**WOLVERINE COAL PROJECT
Wolverine EA Certificate and
Mine Permit Amendments - 2.4 Mtpa, May 2005**

**Re: Wolverine Coal Project - Application for Amendment to
Environmental Assessment Certificate M04-01, and
Mine Permit No. C-223**

This Amendment Application package documents changes to project components related to a planned increase in annual production from 1.6 MT to 2.4 MT.

2.2.2.2 Process System in the Coal Preparation Plant

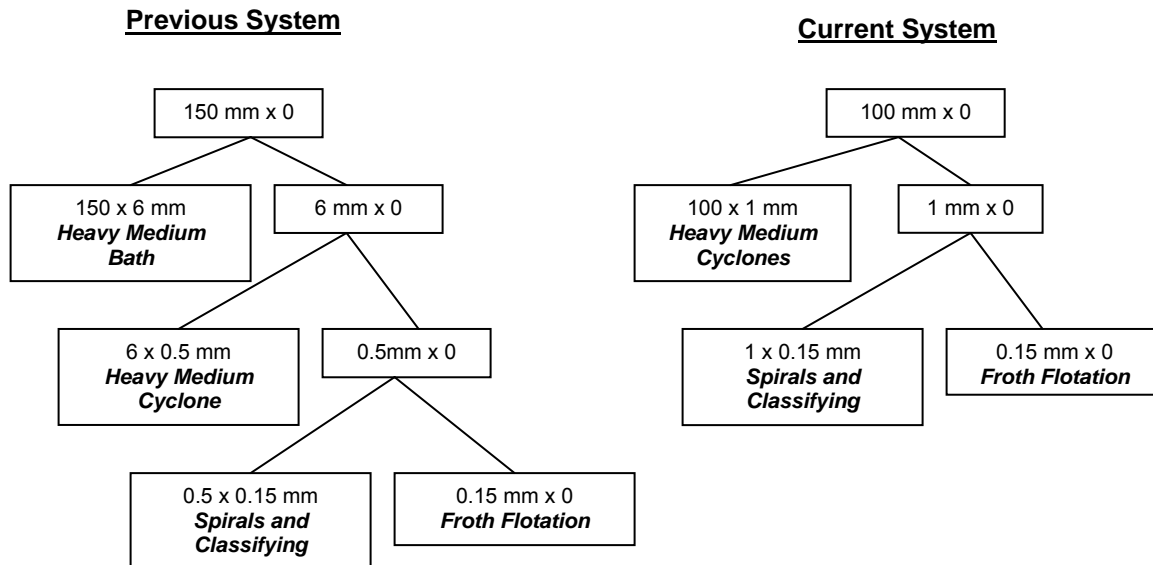
The general approach of using heavy medium magnetite slurry to process coarse coal and froth flotation for the ultra fine coal remains the same as previously presented. As noted above, there is a reduction in topsize from the rotary breaker (150 to 100 mm), which allows for a simplification and changes to the plant classification and separation processes. These changes only impact the internal workings of the coal preparation building. Below is a simplified flow chart comparison of the separation sizing and main coal cleaning processes used between the system presented in the EA and Permit applications and what is currently planned.

The most significant difference is removing the Heavy Medium Bath from the process flow and utilizing large diameter Heavy Medium Cyclones to clean the coarse size fraction. As in the previous process the froth flotation circuit will use fuel oil as a collector agent and MIBC as a frothing agent. The nominal throughput from the plant increases from 300 clean tonnes per hour to 450 clean tonnes per hour.

Figure 3.2-1: Annual Explosive Consumption for 2.4 Mtpa & 1.6 Mtpa Production Rates

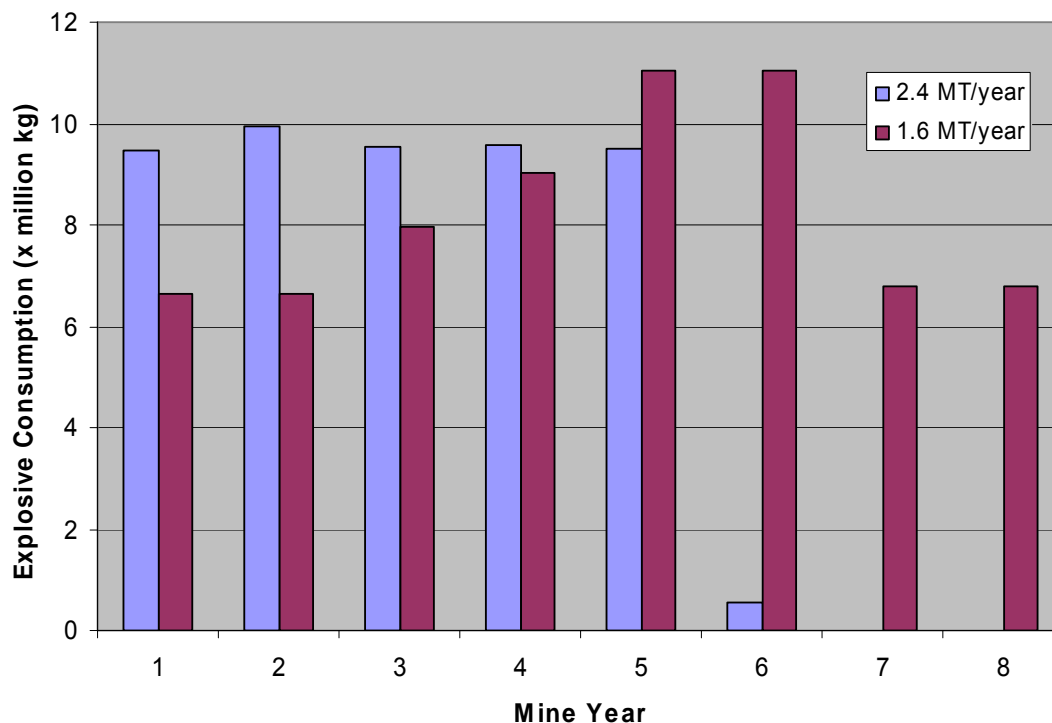
In contrast to metals and sulphate, the export of nitrogen compounds to the environment will reflect the flushing of residual blasting residues associated with the use of nitrogen-based explosives (e.g., Ammonium Nitrate Fuel Oil (ANFO)). Given that annual explosives consumption for the 2.4 MT project will be greater than that for the original 1.6 MT project, annual losses of nitrogen to the environment can be expected to be greater for the 2.4 MT project. As illustrated in Figure 3.2-1, annual explosive consumption for a production rate of 2.4 Mtpa is greater in than that for the original 1.6 Mtpa over the first four years of operations.
